September 2, 2010
NRC3-10-0036

Subject: Detroit Edison Company Response to NRC Request for Additional Information Letter No. 39

**Response to RAI Letter No. 39
(eRAI Tracking No. 4868 Revision 2)**

RAI Question No. 13.03-54

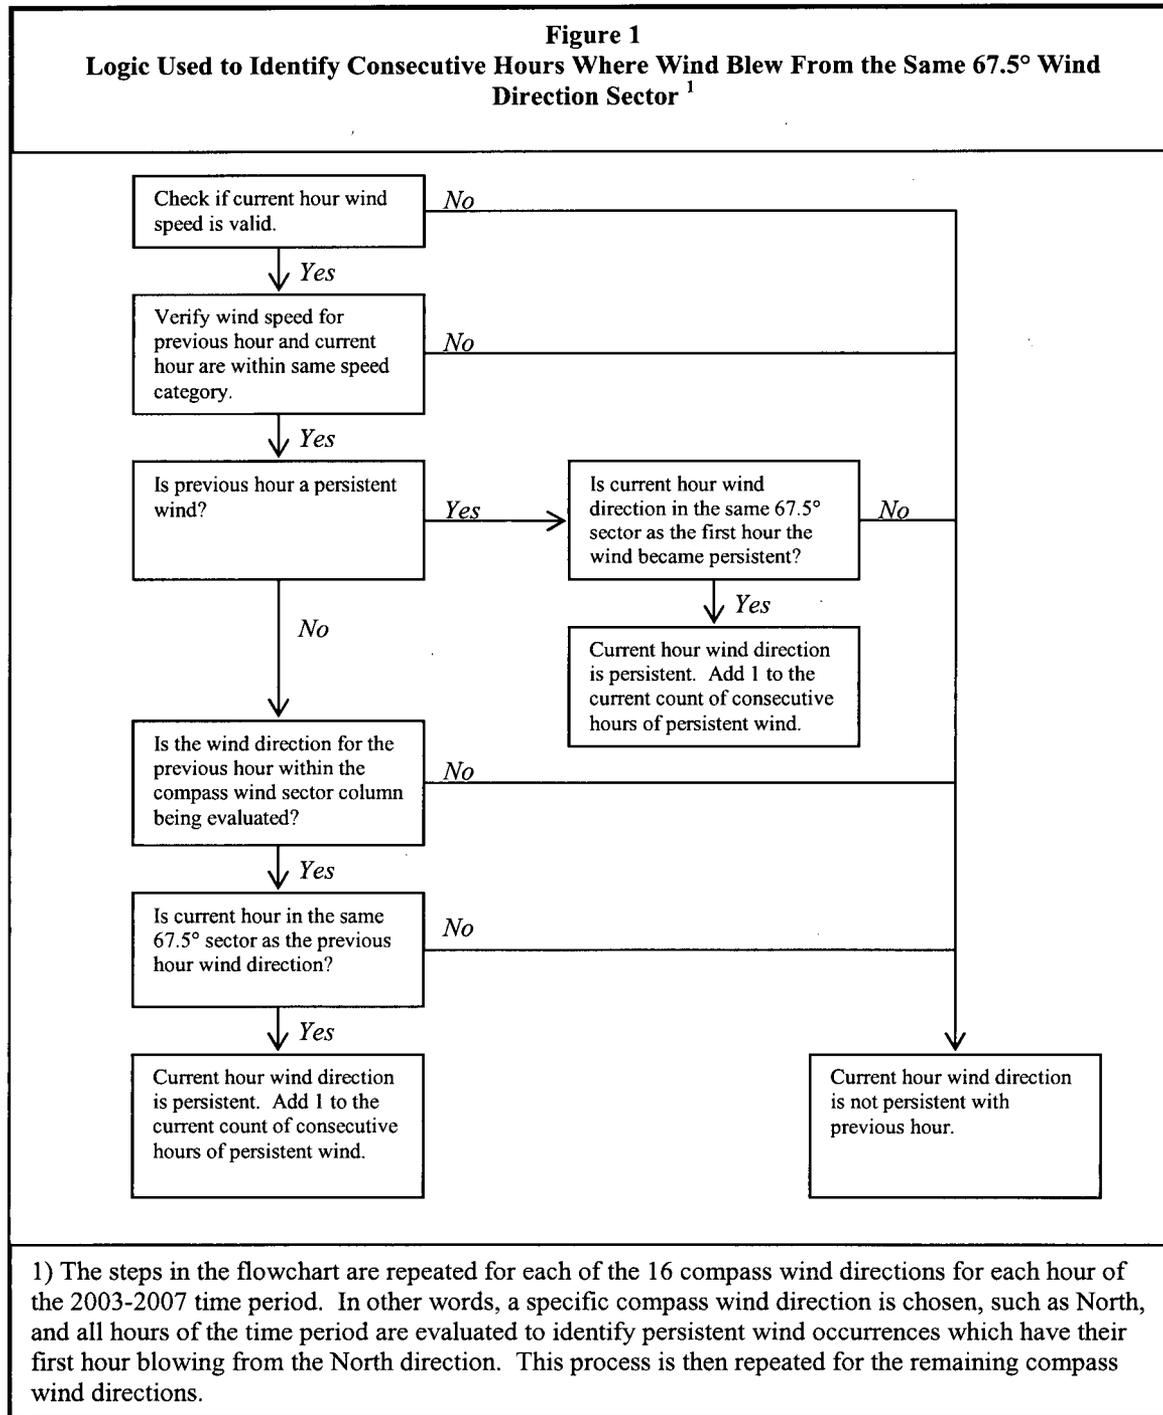
RAI Question No. 02.03.02-9

FSAR Tables 2.3-224 through 2.3-229 and 2.3-236 through 2.3-241 present wind direction persistence summaries for winds blowing from the same 67.5° wind direction sector at the 10 meter and 60 meter levels, respectively, at the Fermi 3 site. The wind persistence tables are based on hourly wind speed and direction data obtained from the Fermi meteorological tower sensors. The methodology used to create the tables includes evaluating each hour and all 16 compass wind directions and identifying occurrences where the wind direction persisted within the same 67.5° wind direction sector for more than one hour. Figure 1 presents a flowchart displaying the steps used to identify consecutive hours where the wind direction blew from the same 67.5° wind direction sector. For this analysis a persistent wind is defined as wind that blows from the same 67.5° sector as set by the wind direction of the first hour of a persisting set of winds. The wind direction of the first hour is also used to determine which single sector wind direction column the persistent wind is classified to blow from. The paragraphs that follow describes in greater detail the steps presented in Figure 1.

As indicated in Figure 1, the first step is to check if the wind speed parameter is a valid number. If the data is missing then the wind direction for that hour is not considered persistent. If the wind speed is a valid number, then the next step is to verify that the previous hour and the current hour wind speed are within the same wind speed category. Separate tables are used to account for each of the wind speed categories (i.e., 0-5 mph, 5-10 mph, 10-15 mph, 15-20 mph, greater than 20 mph, and all wind speeds). For example, FSAR Table 2.3-225 displays the number of occurrences when the wind was blowing from the same 67.5° wind direction sector when the wind speed was greater than zero but less than or equal to 5 mph. For Tables 2.3-224 and 2.3-236, the determination if the wind is blowing from the same 67.5° sector is made without regard to the current and previous hour wind speed.

The third step is to determine if the wind for the previous hour is persistent. If the previous hour wind direction is persistent then this indicates that the wind has blown from the same 67.5° wind direction sector for at least two consecutive hours. For this scenario, the current hour would also be considered persistent if it blows from the same 67.5° wind direction sector as the first hour the wind became persistent. If the previous hour wind direction is not persistent, then the wind direction for the previous hour and current hour are compared to determine if they are blowing from the same 67.5° wind direction section. If they are, then the compass wind direction for the previous hour is used to determine whether future hours blow within the same 67.5° wind direction sector and to see if its wind direction is within the compass wind direction column (i.e., N, NNW, NNE, etc.) being evaluated. If one of the conditions is not met, then the current hour wind direction is not considered persistent.

The steps indicated in Figure 1 are repeated for each of the 16 compass directions and for each hour of the 2003-2007 time period. In other words, a specific compass wind direction is chosen,
